TO ALL ROOTES GROUP DEALERS

SUBJECT: PETROL PIPES FOULING BRAKE PIPES

MODEL: LIGHT CAR RANGE (EXCEPT ALPINE)

Fig. 1.

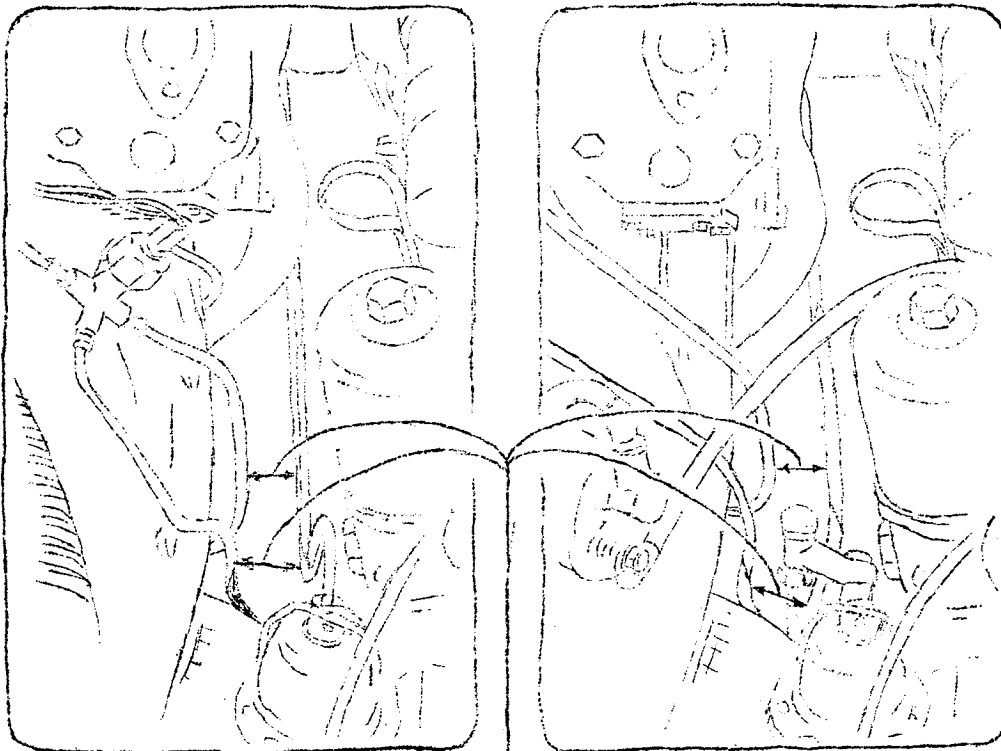
It has been brought to our notice that a condition may arise in service where the feed pipe to the petrol pump can possibly foul either one of the two brake pipes leading down the O/S front wheel arch from the 4-way brake union.

Special care should be taken to ensure that after work on the fuel system, engine etc., there is at least one inch clearance between the petrol and brake pipes. Fig.1 shows the pipe layout on the Light Car Range other than Super Minx, Vogue and Alpine. Fig.2 shows the layout on the current Super Minx and Vogue.

MINIMUM 1" CLEARANCE

Cars coming into your workshops for servicing should be checked.
